JAMES A. FITZPATRICK NUCLEAR POWER PLANT

AMENDMENT TO FACILITY OPERATING LICENSE

Amendment No. 78
License No. DPR-59

SAFETY EVALUATION BY THE OFFICE OF NUCLEAR REACTOR REGULATION

FIGURE 6.1-1

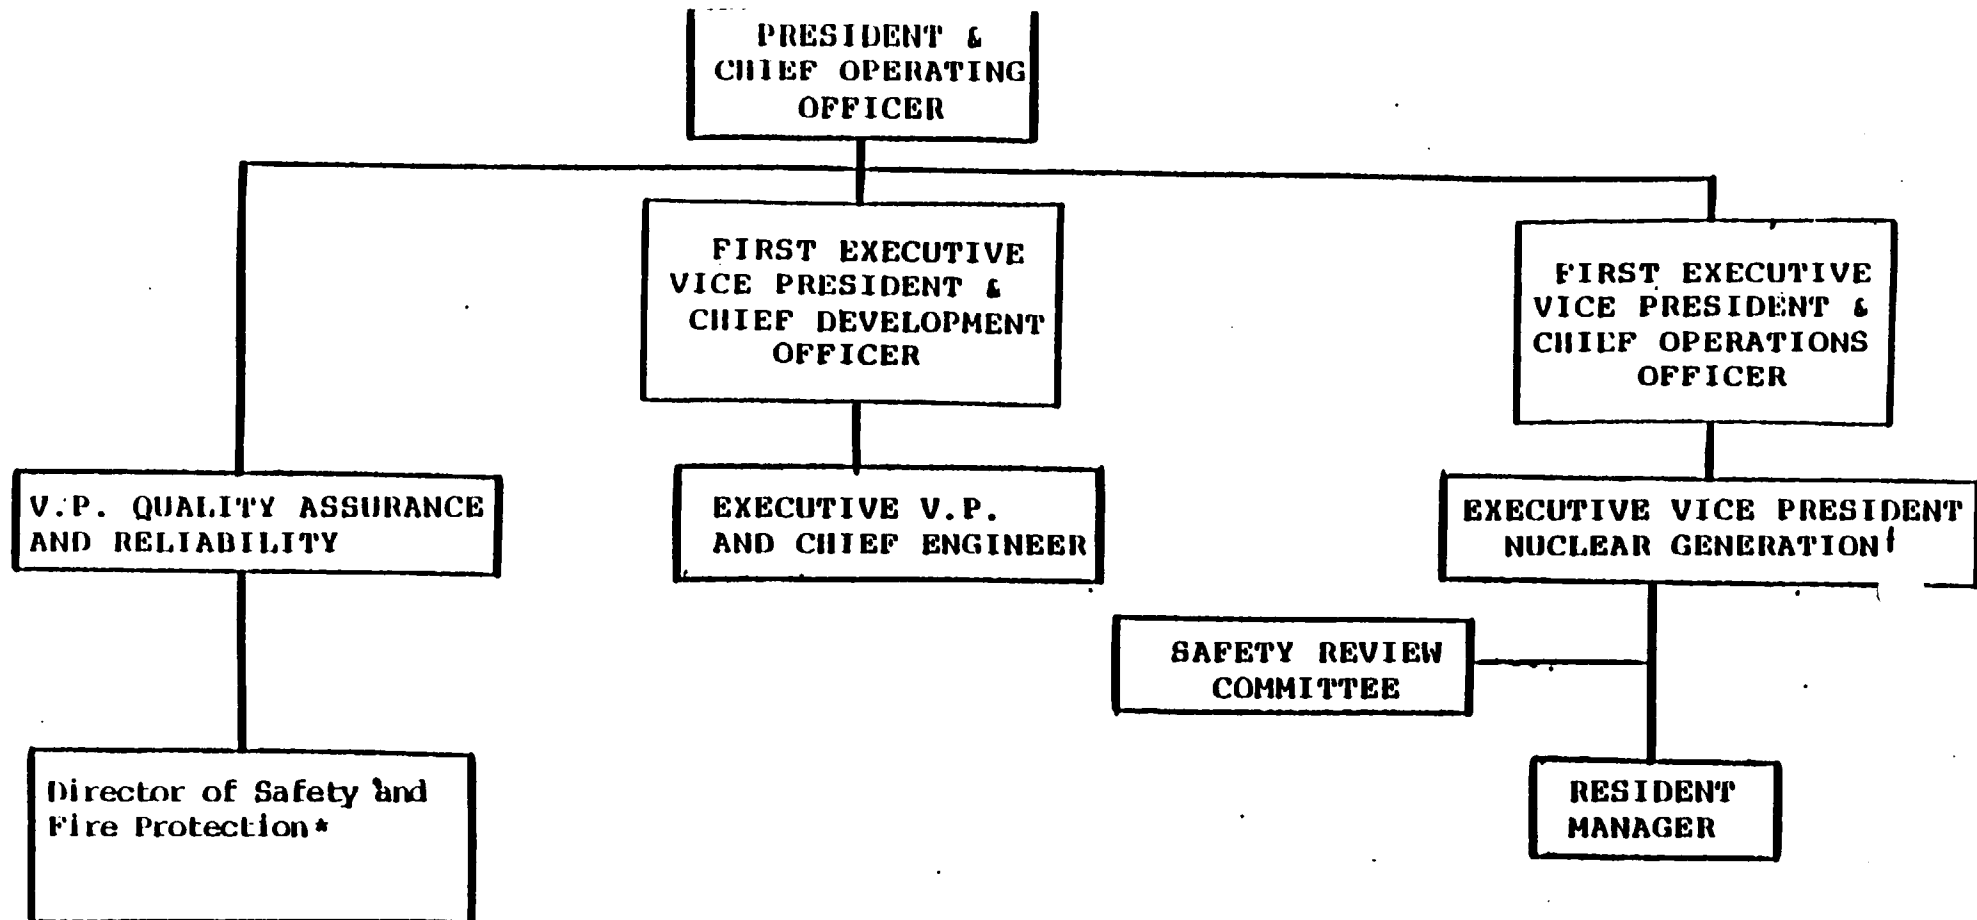
1. The off-site management organization has been revised to add the position of First Executive Vice President and Chief Development Officer and the position of First Executive Vice President and Chief Operations Officer. The title of Executive Vice President Procedures and Performance has been changed to Vice President Quality Assurance and Reliability; and he assumes the duties held previously and, in addition, now performs audits and appraisals of the security program. The title of Senior Vice President Nuclear Generation has been changed to Executive Vice President Nuclear Generation without change of function; and the title of Director of Safety and Fire Protection Procedures and Performance has been changed to Director of Safety and Fire Protection.

Title changes have been made throughout Section 6 of Appendix A and in Figure 5.2-2 of Appendix B to reflect the above reorganization and title changes. The reorganized off-site management organization is shown in revised Figure 6.1-1.

FIGURE 6.2-1

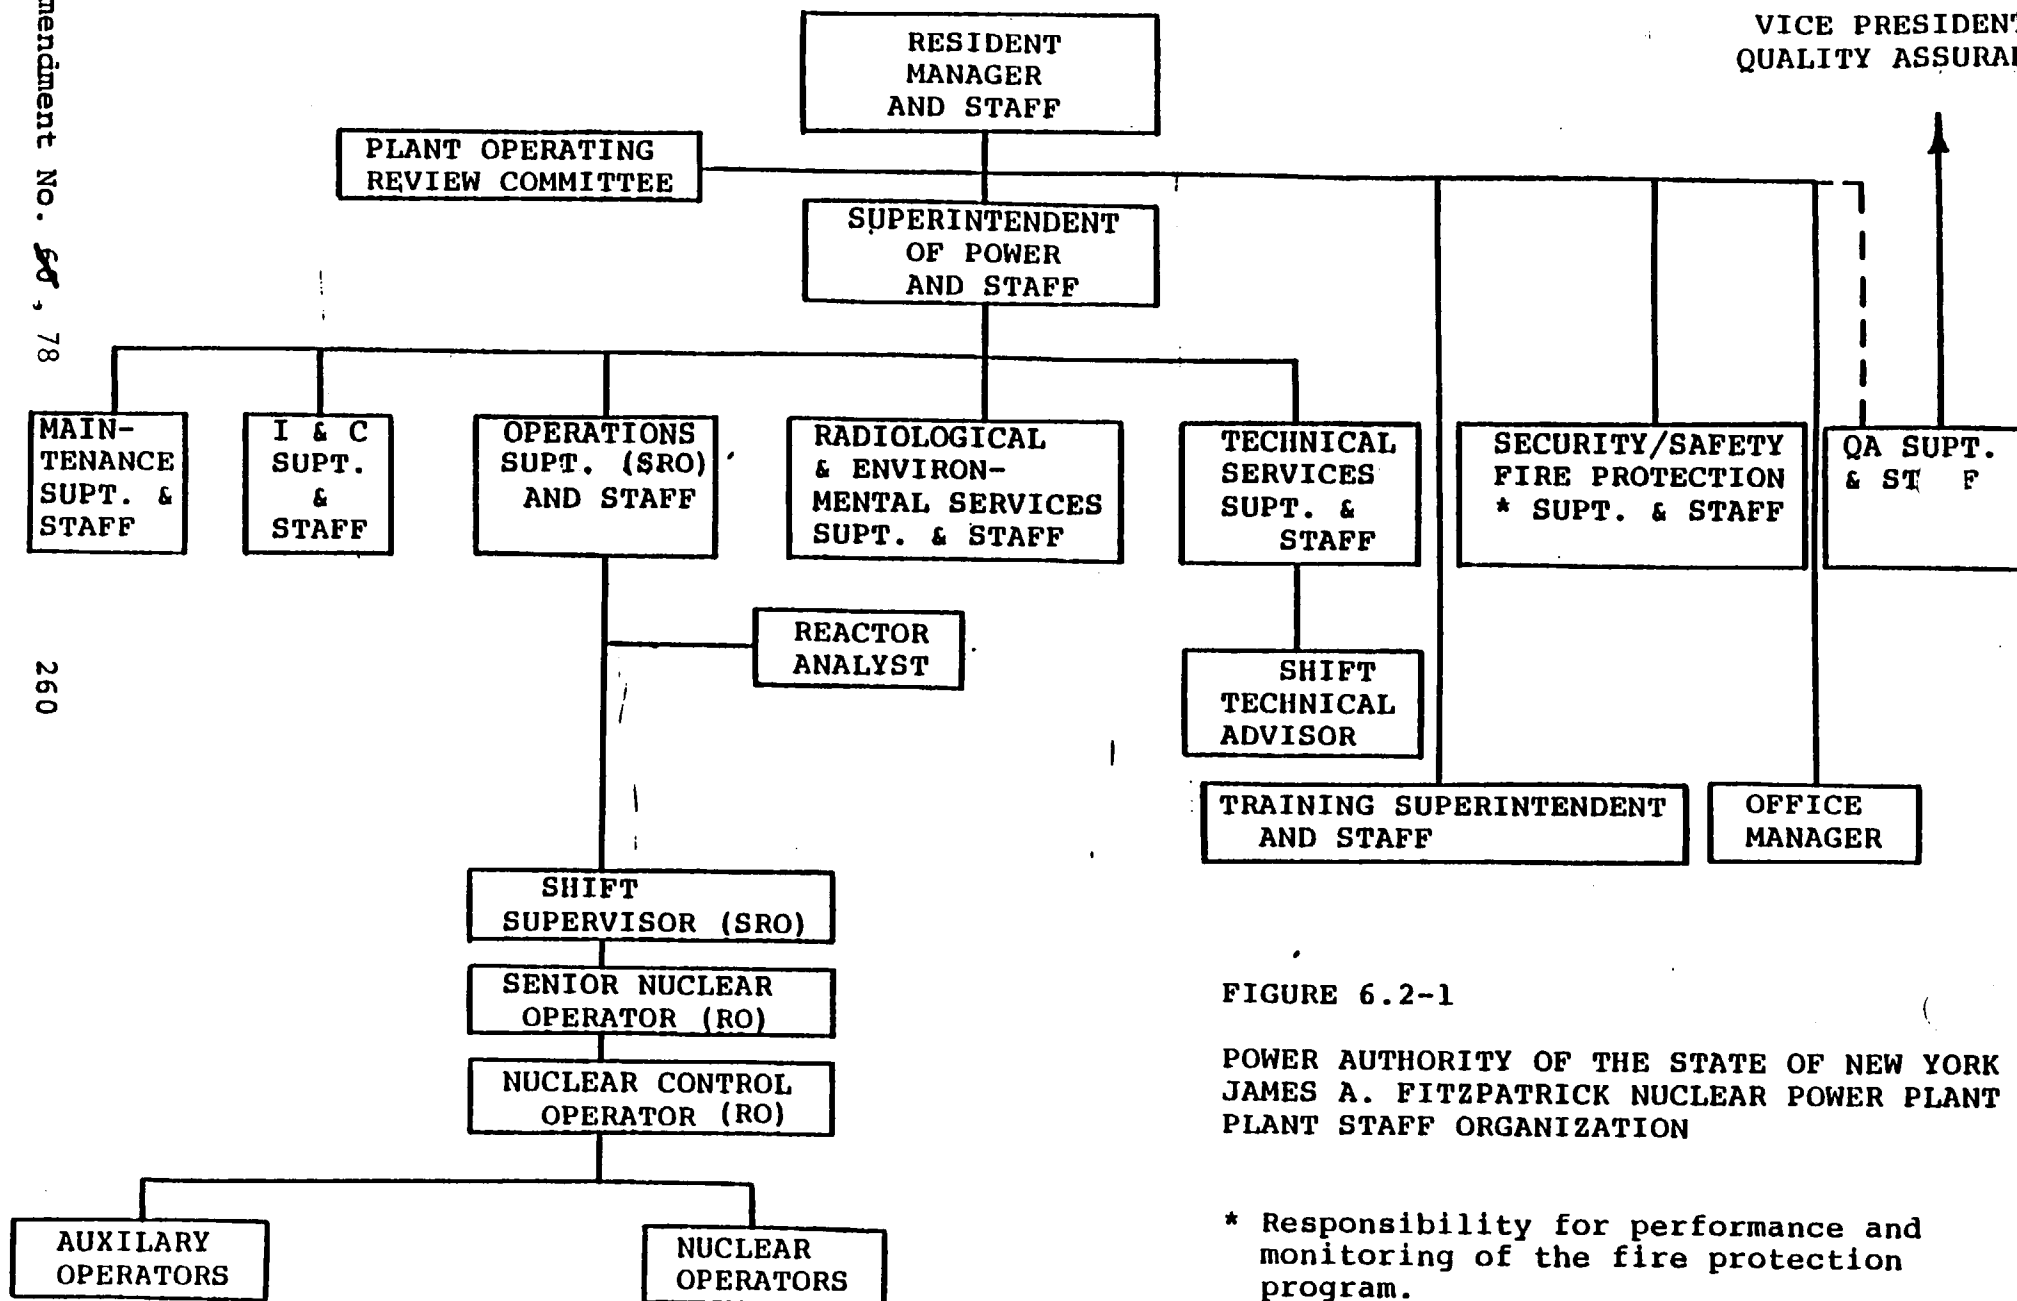
2. The plant staff organization chart has had a footnote added that assigns responsibility for performance and monitoring of the fire protection program. Additionally, the title of Training Coordinator has been changed to reflect the current organization structure. This is shown in Figure 6.2-1.
3. In Section 6.5.2.8, the audit frequencies for emergency preparedness and safeguards contingency plans (Items e and f) have been revised to agree with 10 CFR 50.54(t) and 73.40(d) respectively.
4. The title of the Plant Radiation Protection and Radiochemistry Supervisor has been changed to Radiological and Environmental Services Superintendent in Section 6.11.
